# UNITED STATES PATENT AND TRADEMARK OFFICE

| APPLICATION NO. | FILING DATE | FIRST NAMED INVENTOR | ATTORNEY DOCKET NO. | CONFIRMATION NO. |
|-----------------|-------------|----------------------|---------------------|------------------|
| 09/577,932      | 05/25/2000  | Shigeyuki Maruyama   | 000663              | 4823             |

**Office Action Summary**

## **DETAILED ACTION**

**FIG. 2**

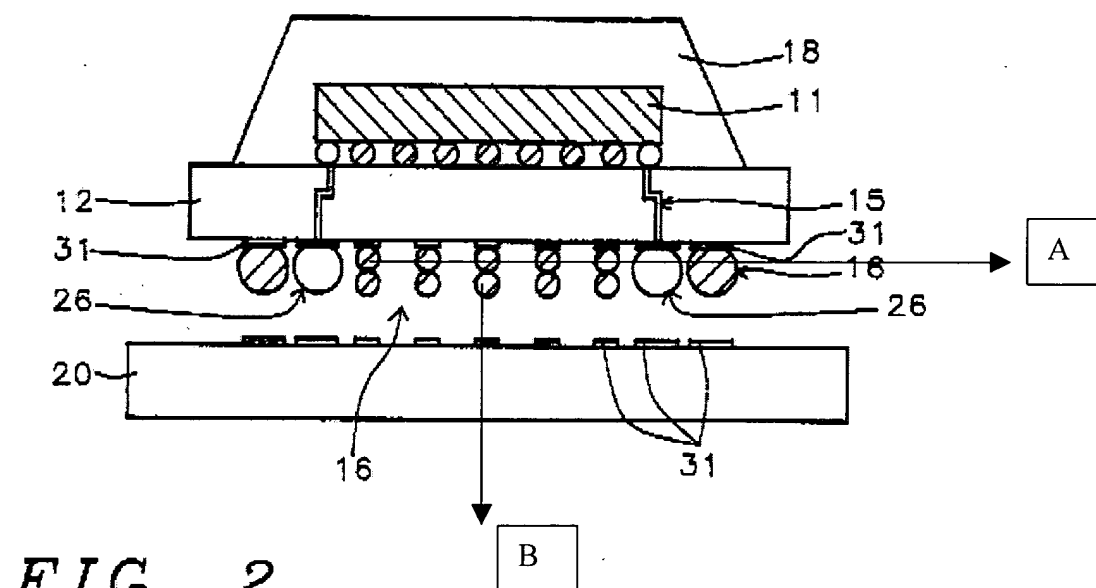
Beddingfield does not disclose a redistribution layer having a plurality of electrode pads and conductive patterns connecting the electrodes of the semiconductor element to the respective electrode pads and at least one electrode part comprising one of the metal posts and a protruding electrode attached to a top of the one of the metal posts. However, Ho discloses in Fig. 2 a redistribution layer (12) having a plurality of electrode pads (31) and conductive patterns (15) connecting the electrodes of the semiconductor element (11) to the respective electrode pads and

at least one electrode part (A and B) comprising one of the metal posts (A) and a protruding electrode (B) attached to a top of the one of the metal posts. Thus, it would have been obvious to one of ordinary skill in the art at the time when the invention was made to modify Beddingfield by using the redistribution layer as taught by Ho. The ordinary artisan would have been motivated to modify Beddingfield in the manner described above for at least the purpose of handling both ends of the wire-width spectrum (column 1, lines 29 ~ 30).
